Collimator Design Meetings

Minutes of the meeting 85 (15/09/2006)

2 in 1 Collimators (TCL(a), TCTV(b))

Sections TCLIA T0002094PL

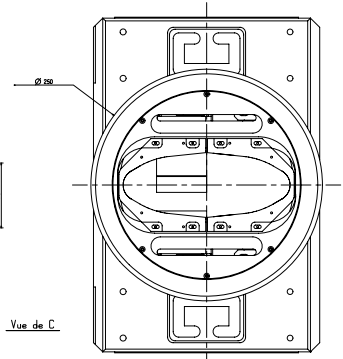
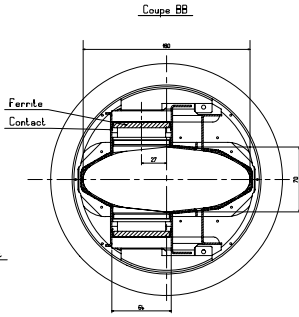
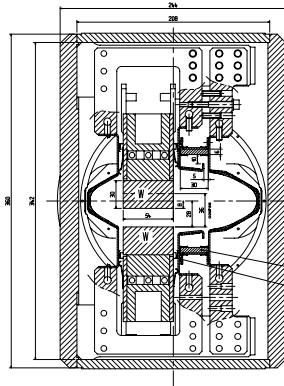
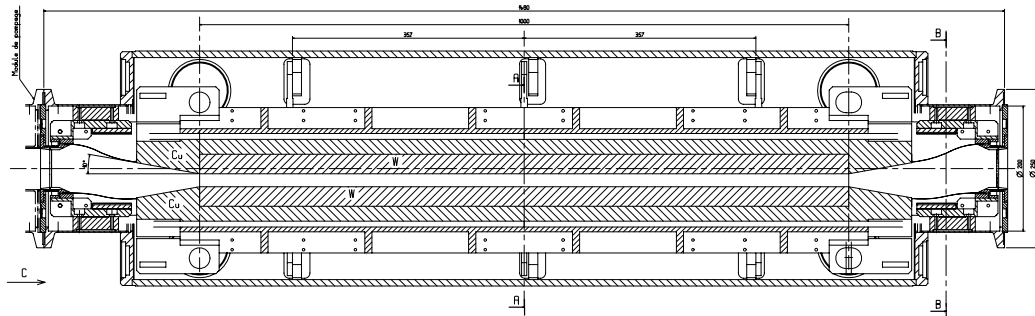
- The stroke initially proposed (-27mm / + 8mm) can be accepted, but an aperture increased to 28mm would be preferable. This figure is compatible with present design, so it is decided to increase the total stroke to 36 mm (-28mm / +8mm)

- The 5th axis stroke (+5 mm / -10mm) is sufficient to ensure a correct aperture for the 2nd non-collimated beam
- A requirement for an additional alignment system to adjust the collimator jaws with respect to each beam crossing-angle, was considered but quickly abandoned as it is not strictly necessary and would exceedingly complicate and slow-down the design.

- Tungsten jaw could be made lighter by replacing the 2 tapered ends with copper and reducing the thickness from 30 mm to 20 mm.
- Material for TCL jaw must be Carbon/Carbon as for TCL(b) standard collimators.

- A clutch device shall be included in the 2in1 design.
- Remarks transmitted by e-mail by A. Grudiev (see below) will be taken into account

1. good thermal contact between the ferrites in the transition regions behind the longitudinal (the longer ones) rf fingers. We discussed this with Alessandro last time. These ferrites can get up to 1 W of average power per piece.

2. to provide good electrical contact in the vacuum flange region as close to the elliptical beam pipe as possible. we discussed this problem with you in my office last time ...

A drawing showing the approved design and already including some of these recommendations is attached ([T0002094PL](#)). Roger will now proceed to the detail design giving highest priority to the components to be ordered first (i.e. Carbon/Carbon jaw, Glidcop supports, Tungsten jaw, Stainless steel components).
